42 HONEYSUCKLE DRIVE COTTAGE CREEK PRECINCT NEWCASTLE

STATE SIGNIFICANT DEVELOPMENT (SSD-10378)
DEVELOPMENT MODIFICATION 2

ARCHITECTURAL DESIGN STATEMENT

NOVEMBER 2021

5.1 DESIGN CHANGES EIGHT FLOOR

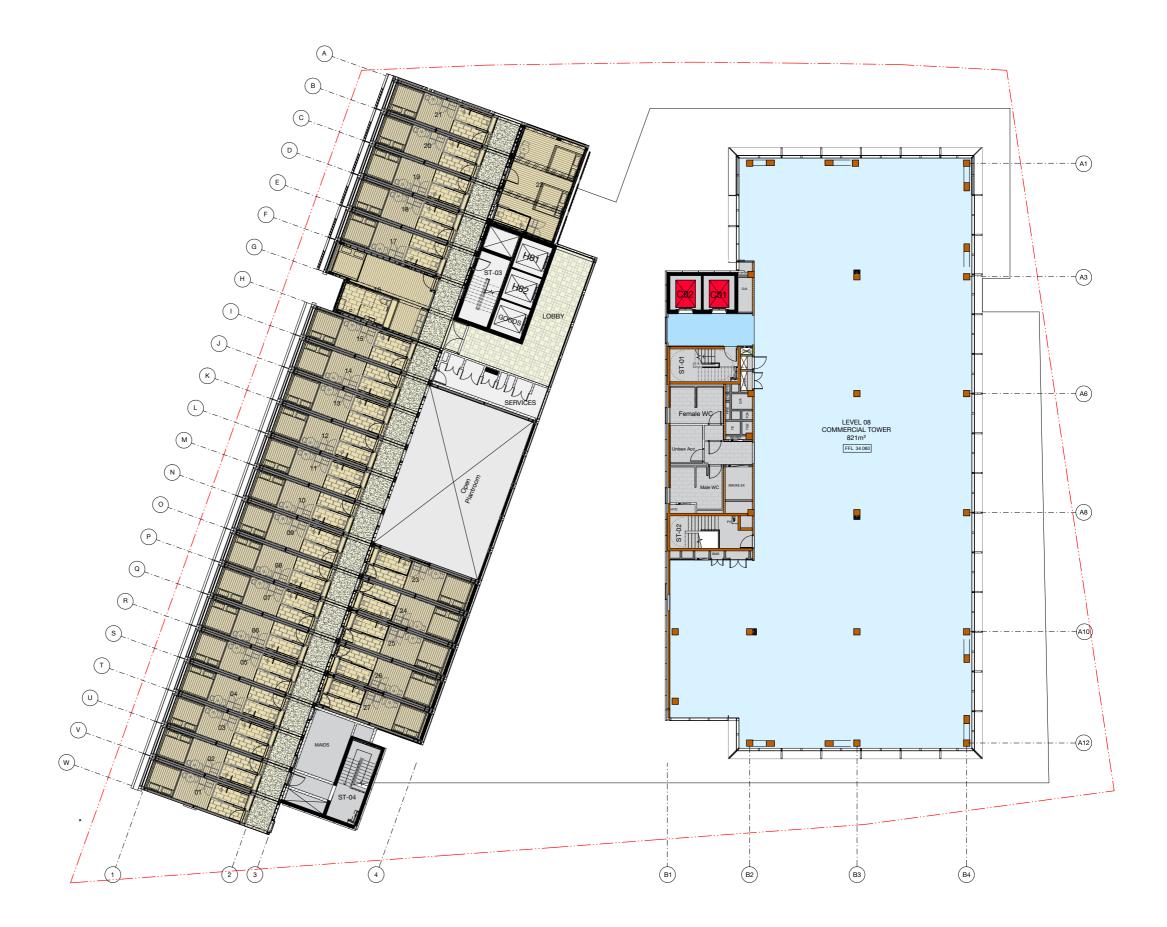
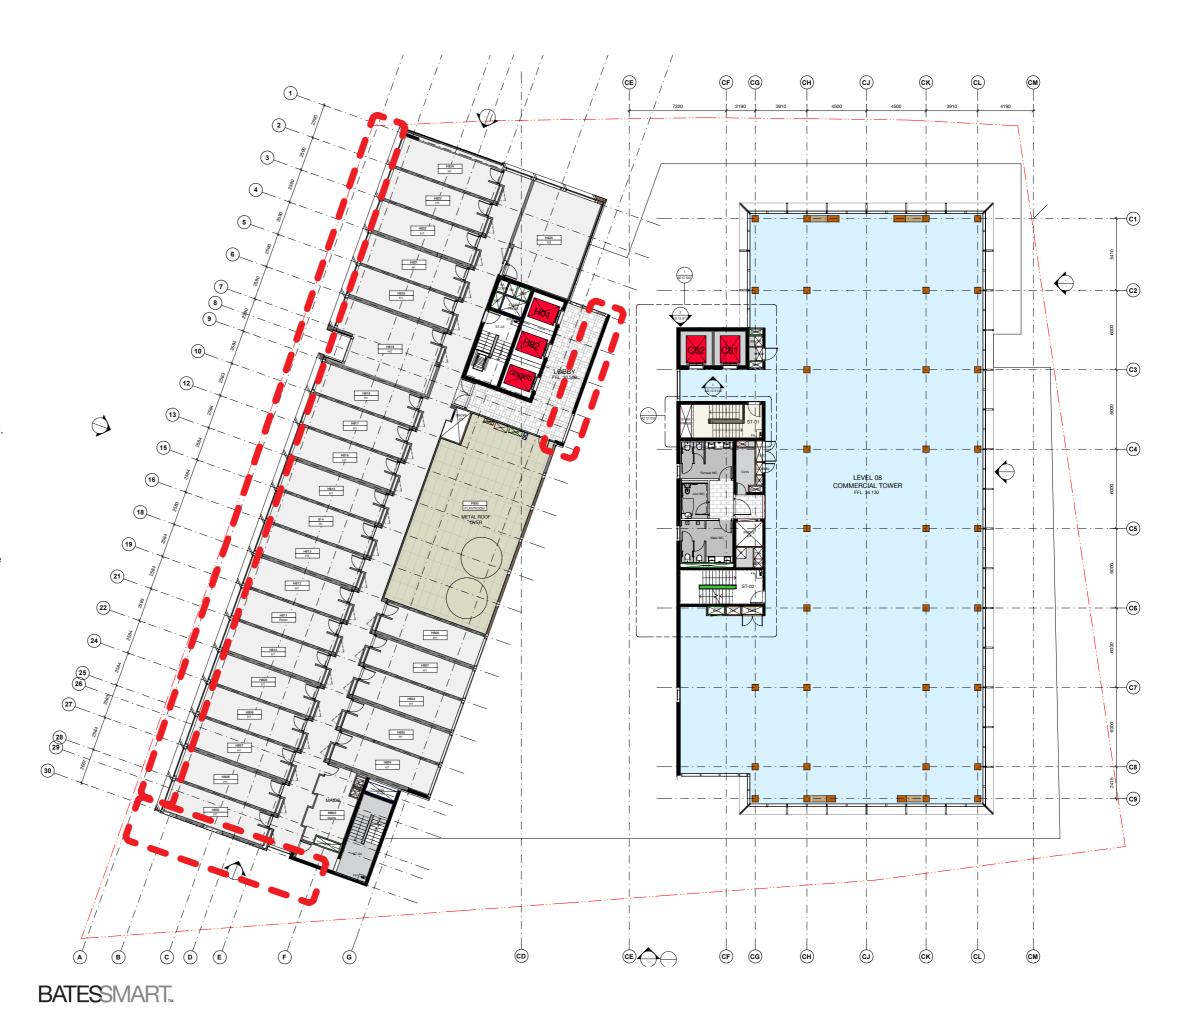
- 1 / South west end of the hotel 1 room from every level omitted.
- 2 / Western hotel facade sunshading design amended
- $3\,\mbox{/}$ Hotel modular construction methodology amended to a traditional built form.
- 4 / Facade amended outside lift lobby. This is now concrete construction rather than glazing to increase privacy between the hotel and commercial tower.

6.1 DESIGN CHANGES ROOF

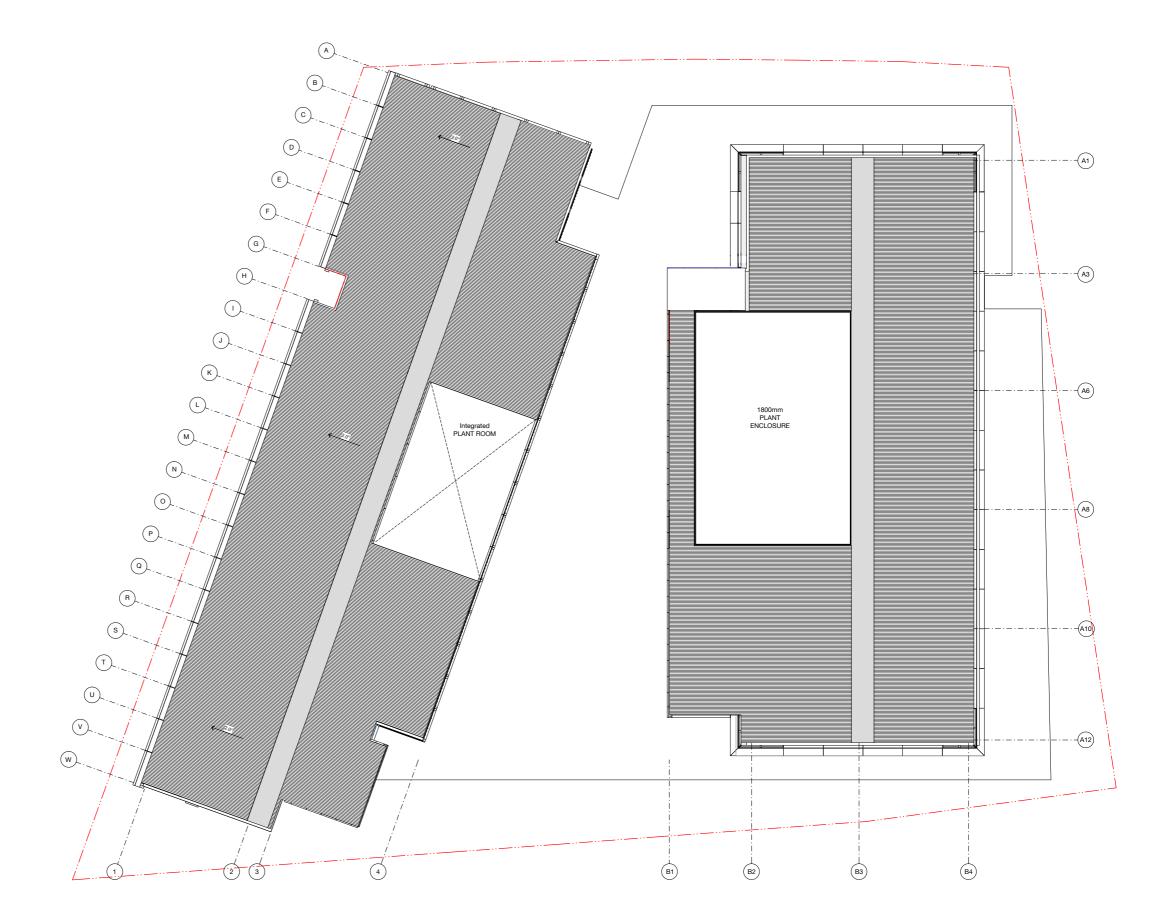
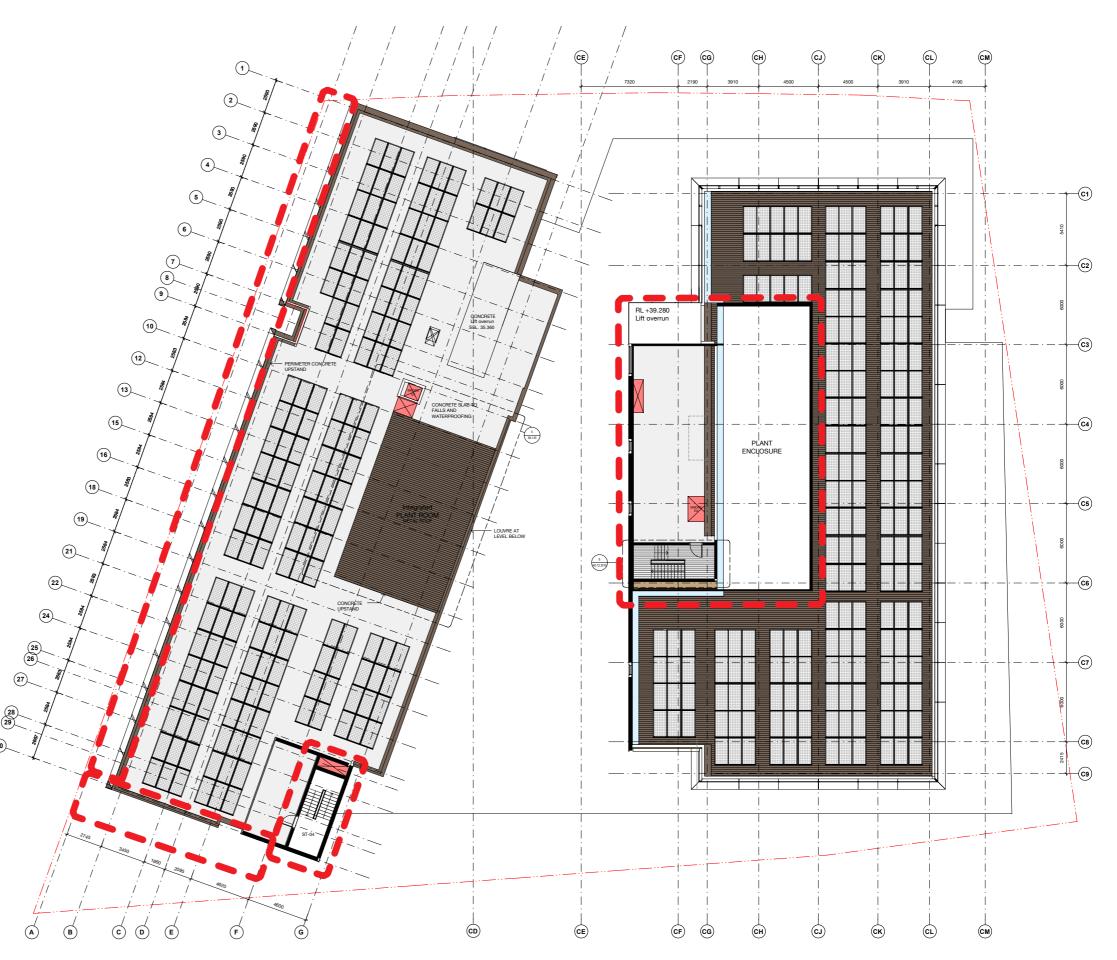
- 1 / South west end of the hotel 1 room from every level omitted.
- 2 / Western hotel facade sunshading design amended
- $3\,\slash$ Commercial tower external plant space increased in size
- $4\,/\,\textsc{Fire}$ stair from commercial tower and hotel extended to roof access.

7.1 DESIGN CHANGES NORTH ELEVATION

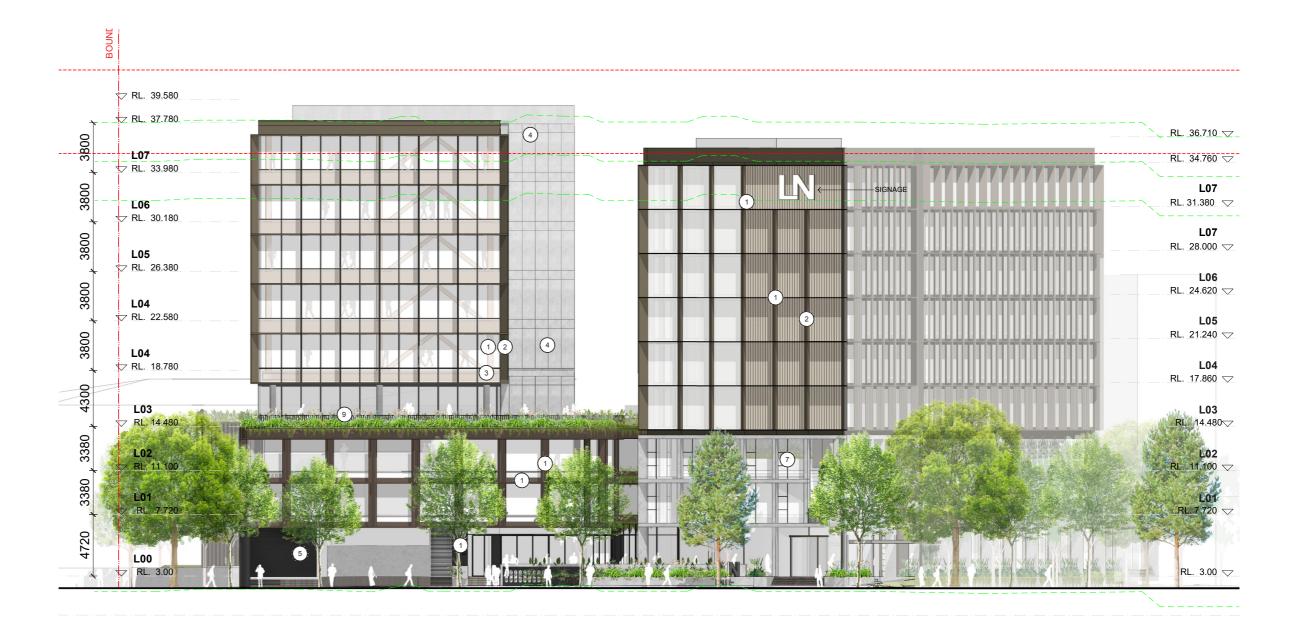
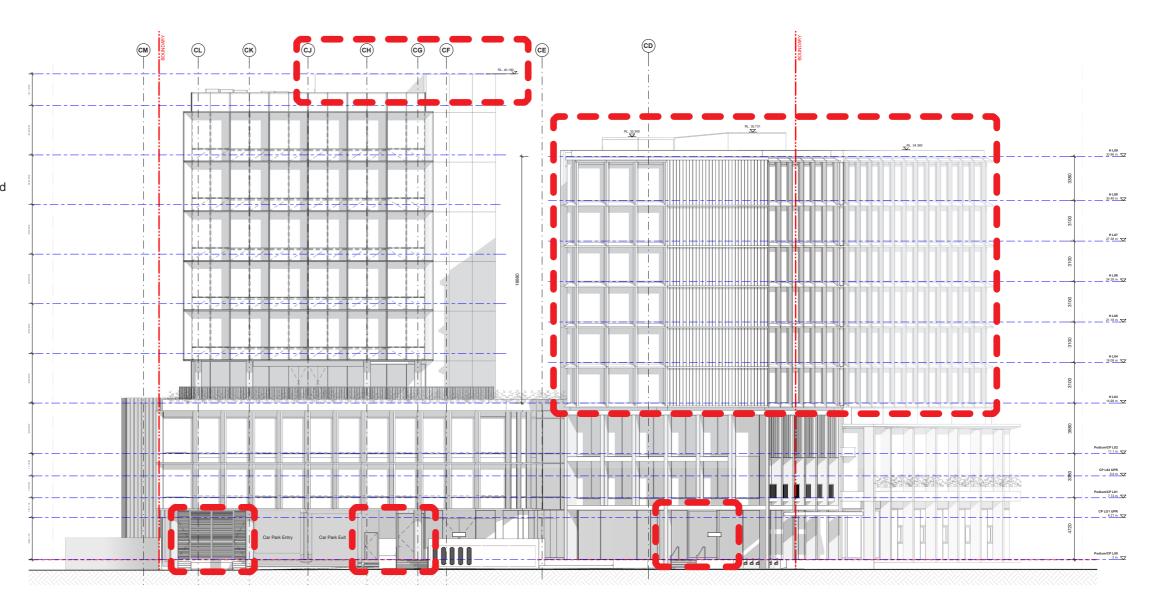
- 1 / Substation location shifted to align with structure over
- 2 / Commercial lobby and associated external access stairs shifted
- $3\,\textsc{/}\ \textsc{Hotel}$ entry and associated external access stairs shifted
- $4\,/$ Hotel slab to slab levels reduced from 3380mm down to 3100mm. This has resulted in an overall hotel building height reduction..
- 5 / Commercial tower height increased by 600mm to allow for additional plant height

8.1 DESIGN CHANGES WEST ELEVATION

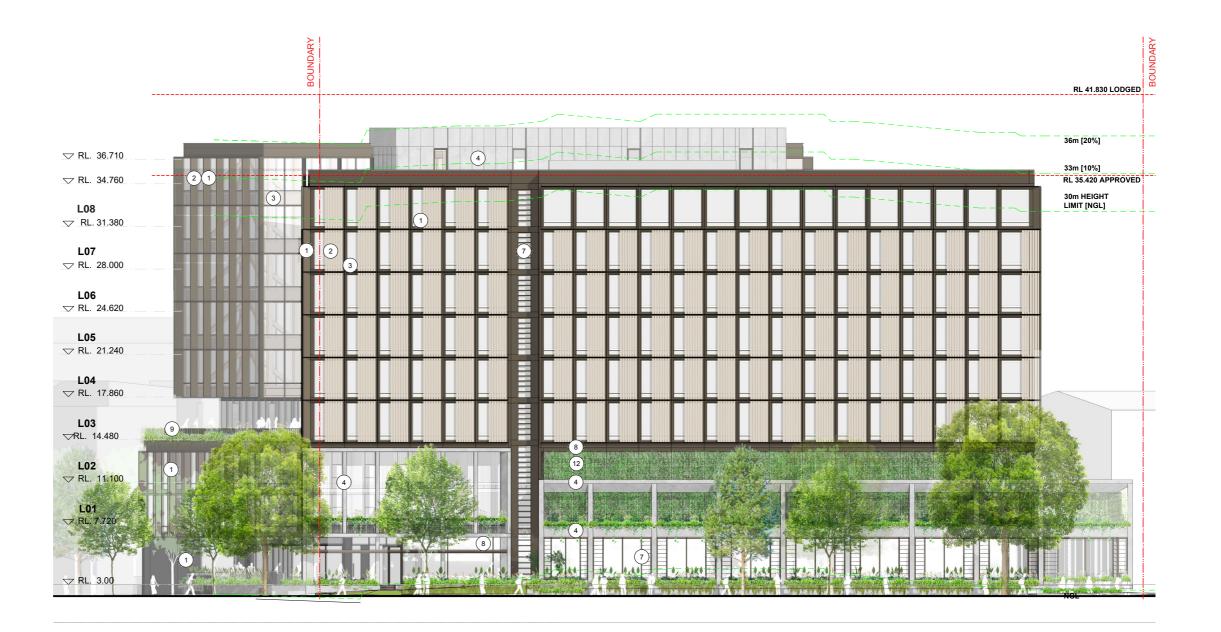
- 1 / Hotel slab to slab levels reduced from 3380mm down to 3100mm. This has resulted in an overall hotel building height reduction.
- $2\,/\,\text{L01}$ and L02 North/west corner amended. External terrace omitted and sunshading added to level L02
- $3\,\textsc{/}\ \textsc{/}\ \texts$
- 4 / Arbor structure has been pulled back at the south boundary.

10.1 DESIGN CHANGES SOUTH ELEVATION

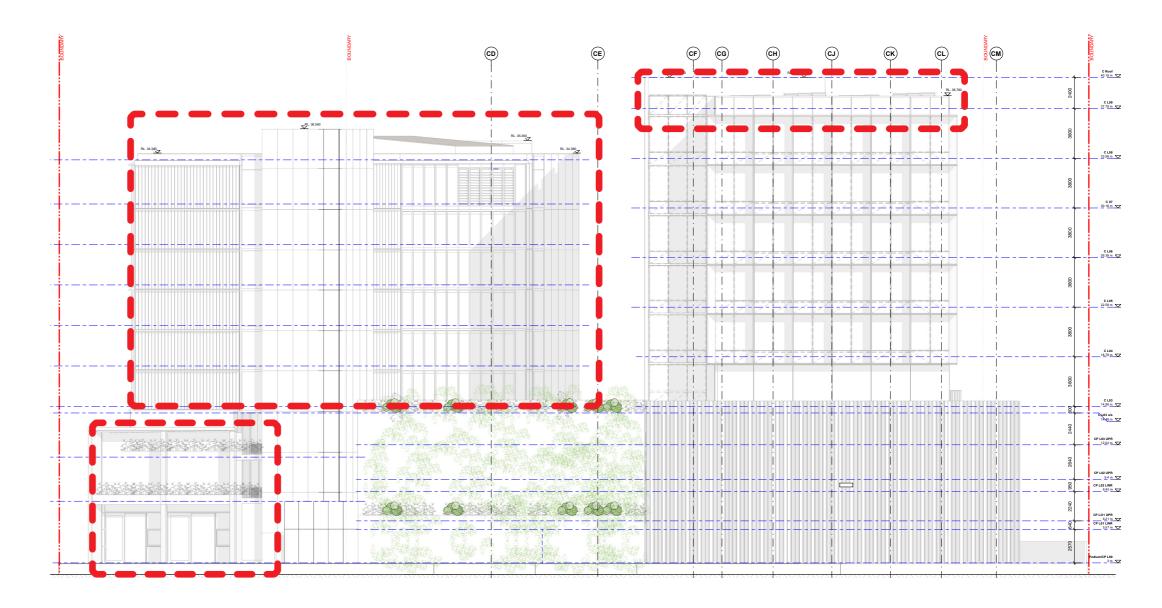
- 1 / Commercial tower height increased by 600mm to allow for additional plant height.
- 2 / Perimeter edge planters to Level L03 omitted
- 3 / Hotel slab to slab levels reduced from 3380mm down to 3100mm. This has resulted in an overall hotel building height reduction.
- $4\,/$ Hotel south end of building has been reduce in length by 1 hotel room width.
- 5 / Arbor structure has been pulled back at the south boundary.

11.1 DESIGN CHANGES EAST SECTION

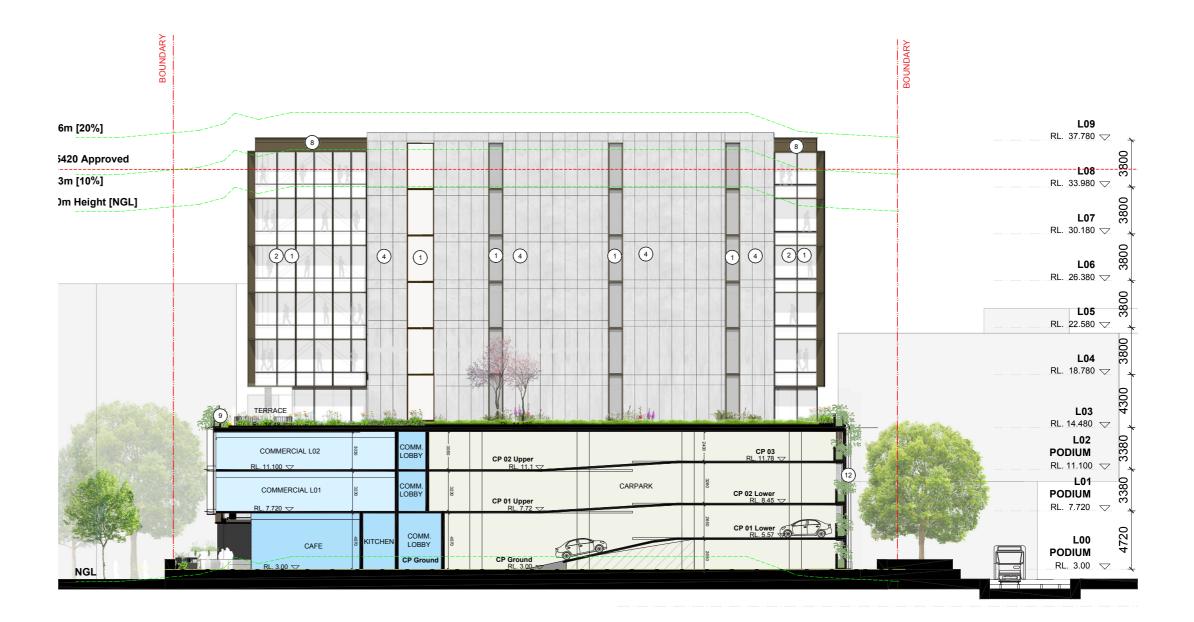
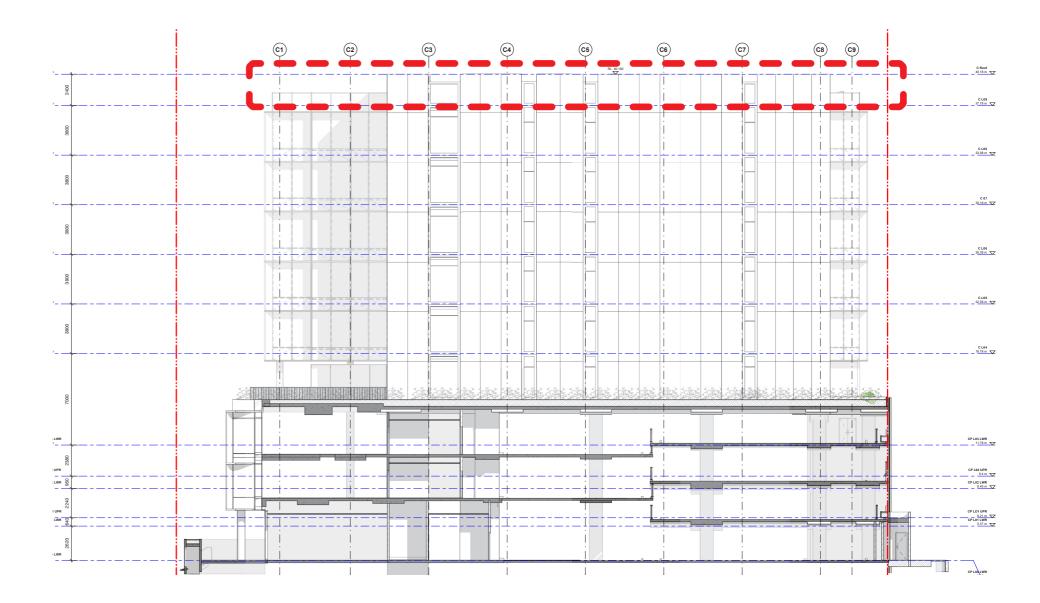
1 / Commercial tower height increased by 600mm to allow for additional plant height.

12.1 DESIGN CHANGES WEST SECTION

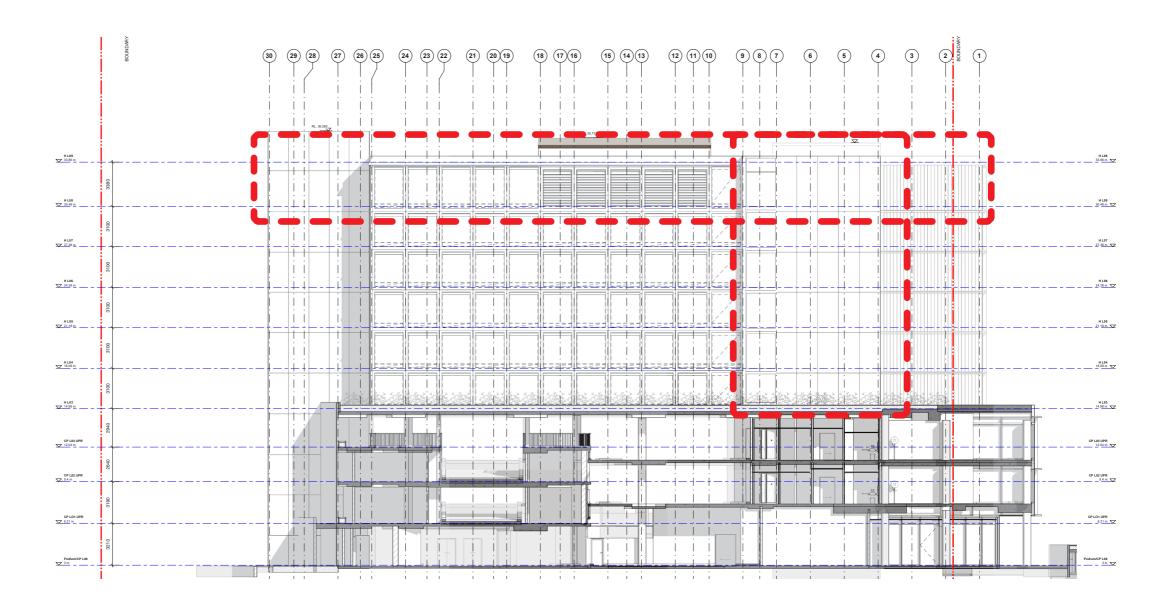
- 1 / Hotel slab to slab levels reduced from 3380mm down to 3100mm. This has resulted in an overall hotel building height reduction.
- 2 / Facade amended outside lift lobby. This is now concrete construction rather than glazing to increase privacy between the hotel and commercial tower.
